VILLAGE OF MORTON GROVE  
**APPEARANCE COMMISSION**

**CASE**            **AC 26-08**

**Re: Appearance Commission Case AC 26-08  
Request for approval of an Appearance Certificate for building, signage, and landscape plans associated with case PC 26-07, a request for approval of a Special Use Permit for municipal buildings and governmental offices and other facilities in accordance with Sections 12-4-2:C and 12-4-3:D, a Minor Subdivision in accordance with Chapter 12-8, and a Vacation in accordance with Section 12-9-5 for the property commonly known as 6201 Dempster Street in Morton Grove, Illinois (PIN 10-20-104-040-0000, 10-20-104-041-0000, 10-20-104-003-0000, 10-20-104-004-0000, 10-20-104-005-0000, 10-20-104-006-0000, 10-20-104-007-0000 , 10-20-104-021-0000, and 10-20-104-022-0000), all within a C-1 General Commercial District and an R-3 General Residence District with waivers for accessory structures (Section 12-2-6), fences (Section 12-3-5), landscaping (Chapter 12-11), off-street parking (Chapter 12-7), and signage (Chapter 10-10). The applicant is the Village of Morton Grove.**

## STAFF REPORT

**Renderings of Northwest Corner and Southeast Corner, West Elevation**

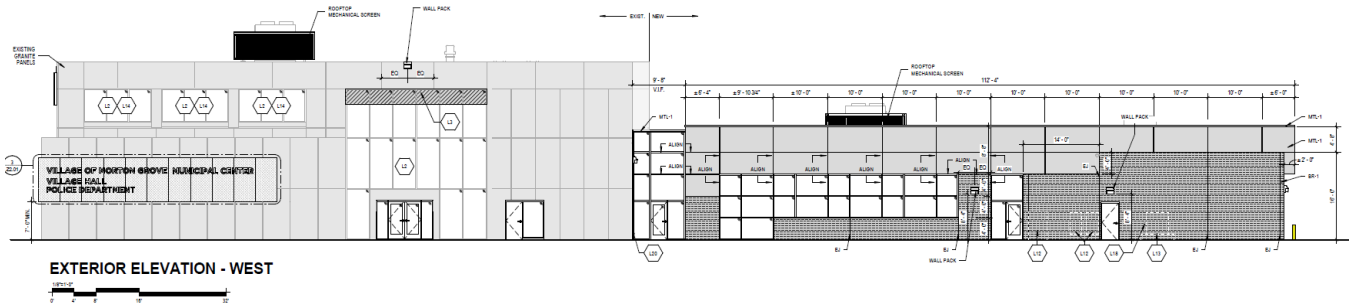
The applicant proposes to reuse the existing building, preserving its current architectural character, and construct a south addition designed to complement the existing structure. The existing building is a contemporary two-story (32.7-foot-tall) commercial office building clad in white and black marbled granite, creating an overall gray appearance, and glass curtain wall systems. The light gray exterior is accented by darker window glazing and framing elements. Large areas of glazing along the Dempster Street elevation provide a prominent and modern appearance along the commercial corridor. Architectural elements include flat rooflines, articulated facade projections, and a primary entrance oriented toward the Fernald Avenue parking lot.

The applicant proposes to wrap the northwest corner of the existing building with a black perforated metal panel, which will serve as a mounting surface for metal channel letter signage along the west elevation, facing the public parking area. The panel is intended to add architectural interest and help break up existing wall space. During evening hours, the perforated panel will be backlit to create a subtle glowing effect, enhancing the building's visual character and providing added interest at different times of day.

The proposed one-story addition will measure 20.7 feet in height and will include the following exterior finishes to complement the existing building:

The proposed materials are depicted in a materials palette included with the application. The proposed materials are not intended to replicate the existing granite, which would be difficult to match, but rather to complement the building's existing design by emphasizing the strong contrast produced by the granite and the darker recessed window areas. All new materials were selected by FGMA for their high quality, durability, and compatibility with the existing building design. All rooftop mechanical equipment will be screened from view from abutting public rights of way.

**Proposed Ornamental Fence Detail**

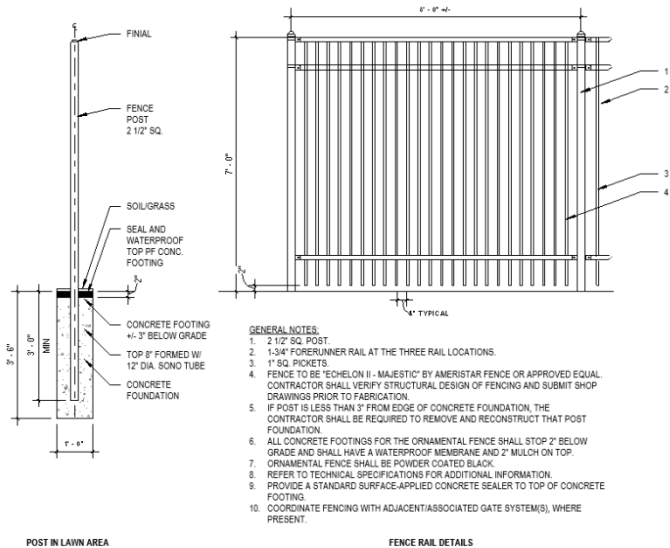
The driveway to the immediate south of the proposed addition will provide through access to Police Department vehicles between Georgiana and Fernald Avenues, connecting to the Department’s garage doors along the south elevation and the secure parking lot to the west. The Police Department parking and driveway areas will be secured by perimeter fencing of two types: (1) seven-foot-tall (7’) black ornamental metal fencing along the north, west, and east fence lines and wrapping to the front building lines of the single-family residences to the immediate south of the subject property, and (2) seven-foot-tall (7’) Trex composite privacy fencing in a coordinating color along the south lot lines.

**Calculation of Primary Channel Letter Sign Face**

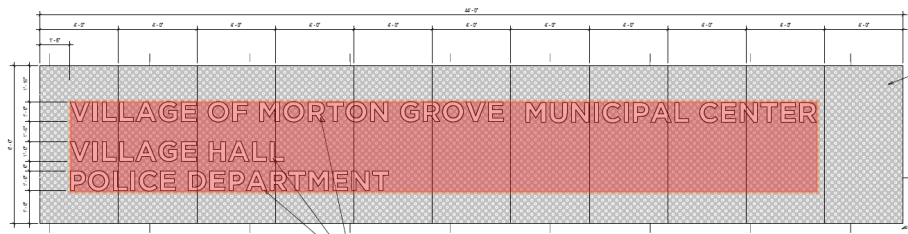
Measurement of the proposed wall signs were taken in accordance with Section 10-10-6:H, which provides that for channel letter signs, “the area of channel letter signs shall be computed by taking the area enclosed within the smallest geometric figure needed to completely encompass each letter, word, insignia, emblem or symbol of the sign.” Based on this methodology, staff calculated a rectangular sign area of 4.5 feet by 38.0 feet, a total area of 171.0 square feet. Although this calculation results in a sign area that exceeds the maximum permitted by Code and therefore requires a waiver, a significant portion of the measured area consists of unused negative space. As a result, the effective visual mass of the signage is considerably smaller than the calculated sign area. Staff finds that the proposed primary wall sign is appropriately scaled to the building elevation and consistent with the intent of the sign regulations, and that the requested waiver is reasonable.
